Kirkbymoorside Town Council

Information for the meeting on Monday 16 June 2025

9. 2025 Kirkbymoorside Feasibility Study and Action Plan for Growth, pursuant to Minute 25010 dated 19 May 2025

Information received from North Yorkshire Council Highways Authority pursuant to Consideration at Minute 25010 dated 19 May 2025:

A170 West - Location of existing signage as indicated by

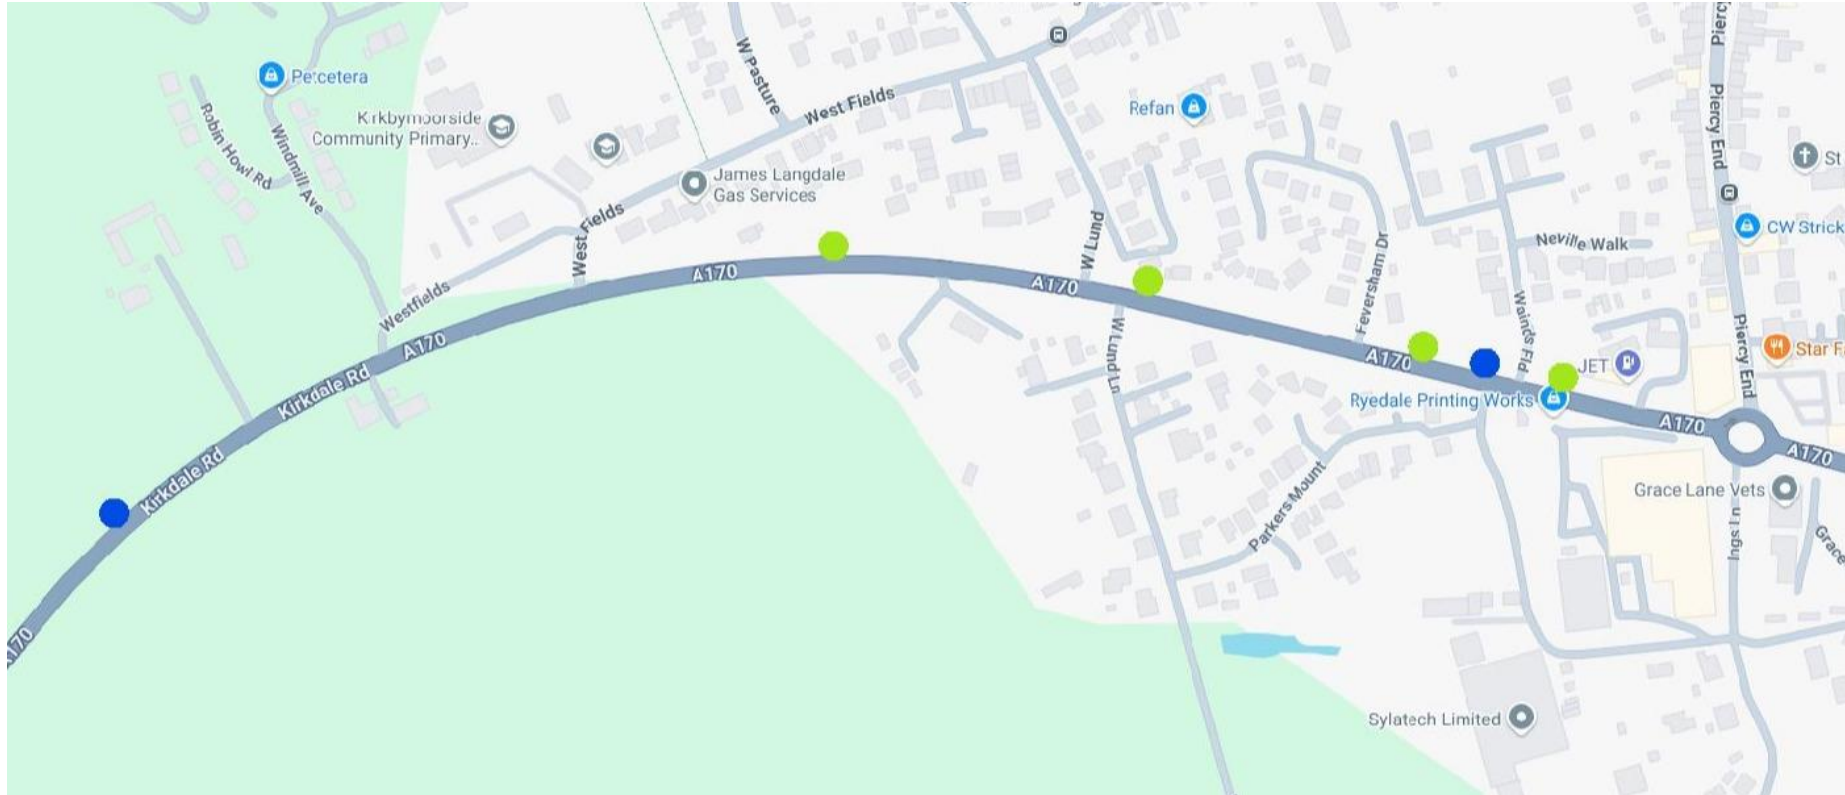
9.4 B Add 2 x large and clear wayfinding signs on the A170 200 – 300 m east and west bound from the main roundabout, along the lines of 'Welcome to Kirkbymoorside, Historic Market Town'.

9.4 E Add further 2 x signs 50 - 100m east and west bound from the roundabout, along the lines of 'Town centre shops, food and toilets ← or → as appropriate.

The 'Welcome to Kirkbymoorside' sign on the west of Kirkbymoorside, on approach from Helmsley, is located on private land, in the hedgerow of Broad View.

Enquiries as to alternative locations on the A170 verge for the length of verge in proximity to the parish boundary, (between Westfields to Kirkdale Lane), have been exhausted. North Yorkshire Council Highways have consistently refused the Town Council's suggestion for alternative sites to relocate the sign onto the highways verge.

A. As you know, there are advanced (green) direction signs on the A170 approaches to the roundabout directing traffic to the Town Centre. On the roundabout itself there are also directional signs to the Town Centre and direction signs to the Library, Golf Club, WC and disabled facilities.

From a Council (North Yorkshire Council) perspective the signs are adequate for the purposes of directing drivers to the Town Centre.

I can understand a desire to advertise further town centre attractions from the A170, food/drink etc. In some instances, it is possible to add a brown plate to an advanced direction sign to advertise attractions, (example pictured). However, the cost of replacing the existing advanced direction signs would be quite significant and not something the Council (North Yorkshire Council) could presently fund.
